THE CITY OF WALTHAM
MASSACHUSETTS

**ENGINEERING SERVICES FOR SEWER AREA 1314 B
BEAR HILL VALLEY & WEST END, 2016**

ADDENDUM NO. 3

March 22, 2016

**SEWER SYSTEM MAP
CITY OF WALTHAM**

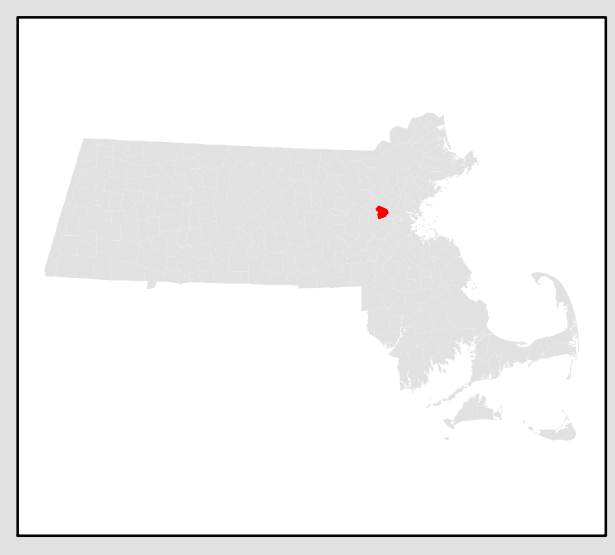
Q1. – Given the scale of the map provided showing the collection system in Area 1314B, it is challenging to determine if there is more than one exit point from the subsystem, and therefore how many meters are necessary to capture all of the flow from the area. Please advise how many meters should be proposed for the 8 week metering periods.

A1. – Attached is the Citywide Sewer System Map. Please reference this to make your determination in the development of a flow metering plan. The object of the flow metering is to maximize the credit received for I/I removal.
